Appendix 2, Page 1 File: OZ 21/002 W4 Date: 2023/02/10

Recommendation Report Detailed Planning Analysis

30 Eglinton Avenue West

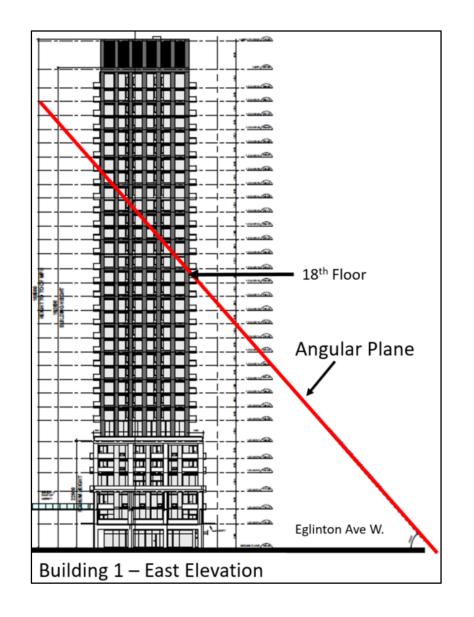
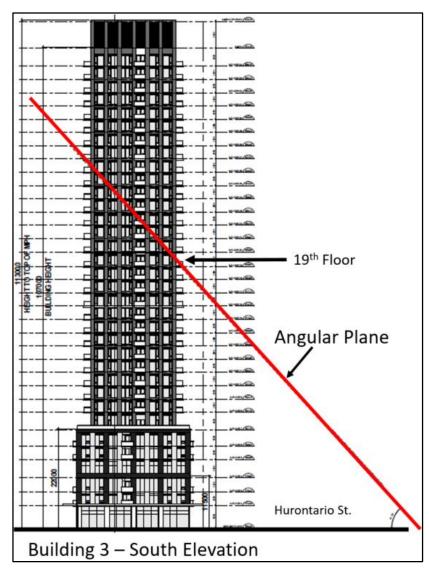
As previously noted, all three buildings exceed the maximum building height of 25 storeys. With respect to transition and scale, the Standards for Sun Shadow Studies contain angular plane criterion for Eglinton Avenue and Hurontario Street. To meet the standard, new buildings sited on the subject property are required to meet an angular plane from the closest edge of the curb on the opposite side of Eglinton Avenue West and Hurontario Street of 48.9 degrees and 47.4 degrees, respectively.

In support of the proposal, the applicant submitted architectural drawings illustrating the angular plane requirements along the street frontages.

Based on the current proposal, neither building meets the angular plane requirements of the City (see below elevations).

It should be noted that it is possible to accommodate tall buildings along the Eglinton Street West and Hurontario Street frontages while meeting the sun shadow and angular plane criterion relating to the public realm. If the buildings remained in their current locations, they would need to provide step-backs where the building intersects with the angular plane.
